MONTGOMERY COUNTY HISTORIC PRESERVATION COMMISSION
STAFF REPORT

Address:	54 Walnut Avenue, Takoma Park	Meeting Date:	4/22/2020
Resource:	Contributing Resource Takoma Park Historic District	Report Date:	4/15/2020
Applicant:	Steve Shira	Public Notice:	4/8/2020
Review:	HAWP	Tax Credit:	n/a
Case Number:	37/03-20W	Staff:	Dan Bruechert
PROPOSAL:	Solar Panel Installation

Figure 3: Typical 3-tab asphalt shingle dimensions.

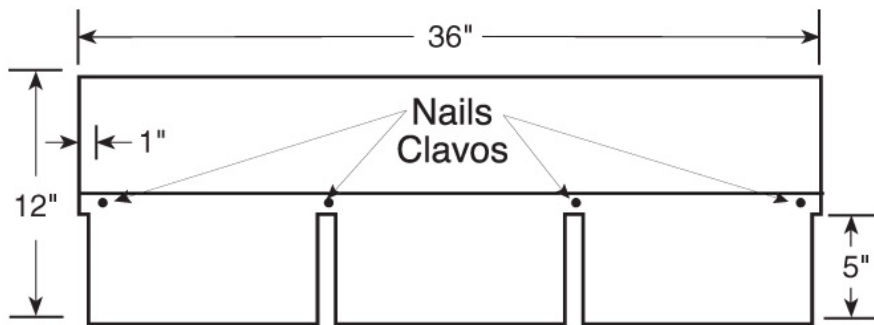
The new shingles are larger than the exposed asphalt shingles. The proposed shingles measure 430 mm × 1140 mm (four hundred thirty millimeters by one thousand forty millimeters), this is approximately 15" × 45" (fifteen inches by forty-five inches). A typical three-tab shingle is 12" × 36" (twelve inches by thirty-six inches), though those shingles are divided so that each visible rectangle is 5" × 12" (five inches by twelve inches), see below. While the proposed shingles are noticeable larger, Staff does not find this difference in dimension to be detrimental to the character of the house or the surrounding district.
